<b>Topic</b>	PSIS 750600B0001 Seat belt pre-tensioner buckle switches - Harness modification
<b>Market area</b>	Russische Föderation (5RU),Australia E04 Bentley rest Asia and Australia (6E04),China 796 VW Import Comp. Ltd (Vico), Beijing (6796),Germany E02 Bentley rest Europe (6E02),Japan E03 Bentley Japan (6E03),Korea, (South) E08 Bentley South Korea (6E08),United Arab Emirates E06 Bentley Middle East and Africa (6E06),United Kingdom E01 Bentley UK (6E01),United States E05 Bentley USA and rest America (6E05)
<b>Brand</b>	Bentley
<b>Transaction No.</b>	2068644/1
<b>Level</b>	EH
<b>Status</b>	Released for publishing
<b>Release date</b>	18-Nov-2022

## **Wiring modification for seat belt pre-tensioner buckle switches**

**P.S.I.S.** 750600B0001

**Figure 1 Right-hand drive vehicles**

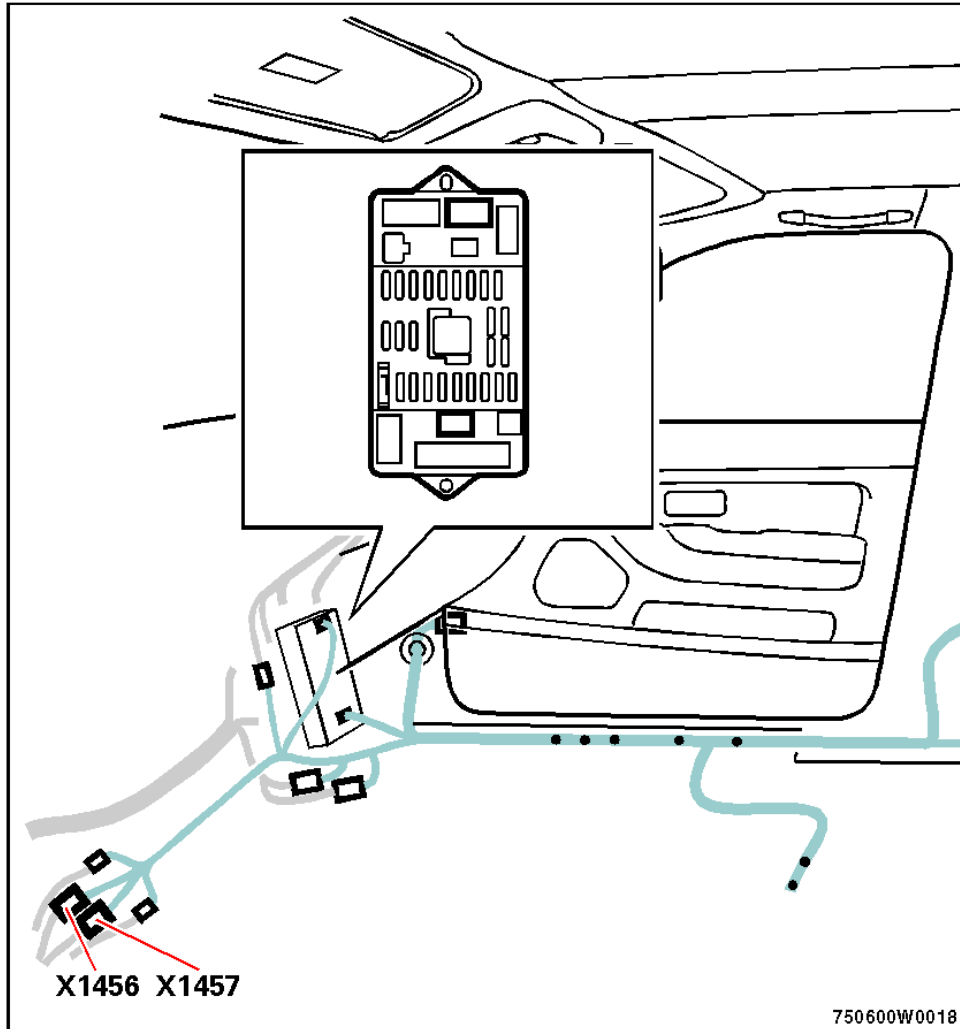
1. With reference to figure 1 identify connector X1457.

2. On the female side of this connector cut the yellow cable at cavity 1. The cut should be made approximately 2 inches (50 mm) from the terminal. Strip back the insulation on each side of the cut and fit a piece of heat shrink.

3. Splice and solder together the two yellow cables from the link looms and the two yellow cables stripped at connector X1457. This splice should have two cables on each side of it.

**Figure 2 Left-hand drive vehicles**

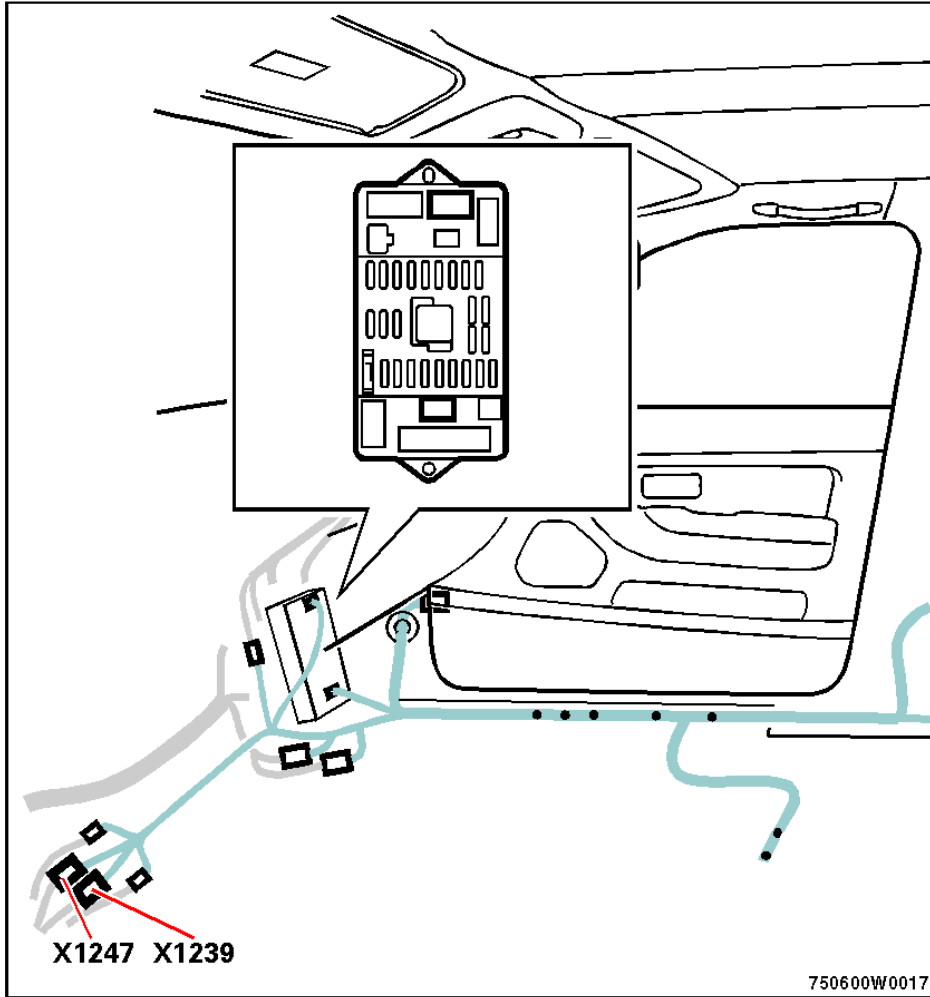
1. With reference to figure 2 identify connector X1239.

2. On the female side of this connector cut the yellow cable at cavity 1. The cut should be made approximately 2 inches (50 mm) from the terminal. Strip back the insulation on each side of the cut. Apply a piece of heat shrink to one of the cables.

3. Splice and then solder together the two yellow cables from the link looms and the two yellow cables stripped at connector X 1239. The splice should have two cables on each side of it.

# Wiring diagram

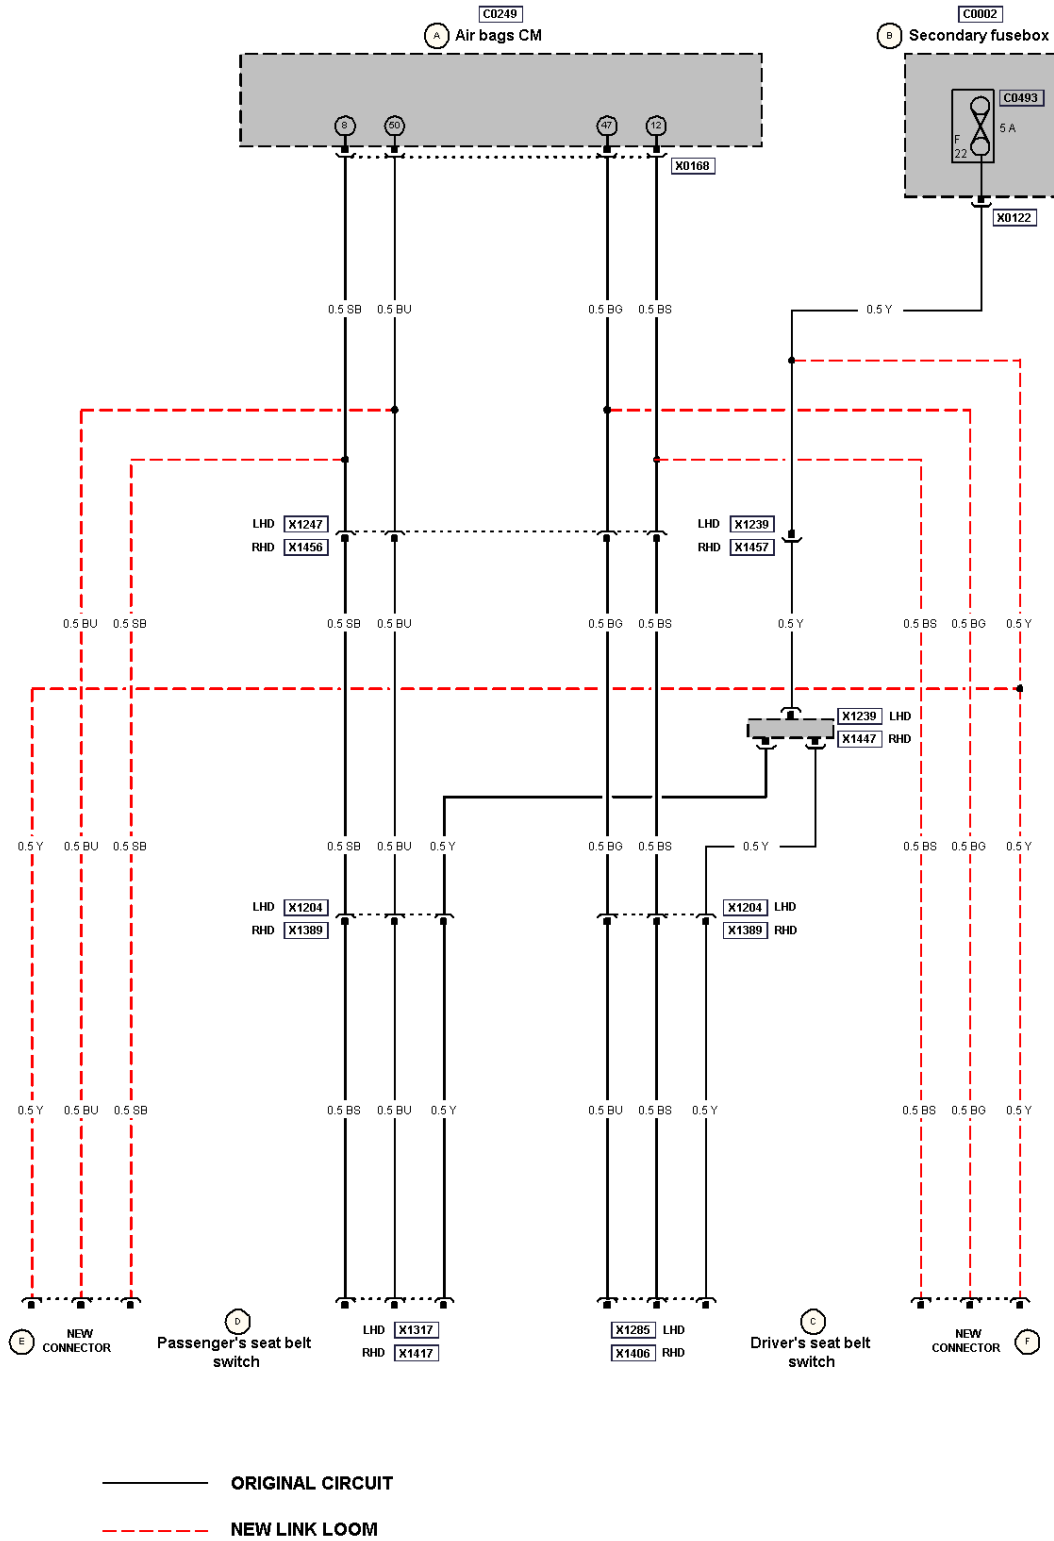
This modification involves the rewiring of the buckle switch circuit, so that these two connectors are not utilised. For clarification this procedure is broken down into two parts, right-hand drive vehicles and left-hand drive vehicles.

A	Air bag control module
B	Secondary fusebox
C	Drivers seat belt switch
D	Passengers seat belt switch
E	New connector - drivers seat belt switch
F	New connector - passengers seat belt switch
	Solid line on diagram designates original circuit
	Dashed line on diagram designates new link loom
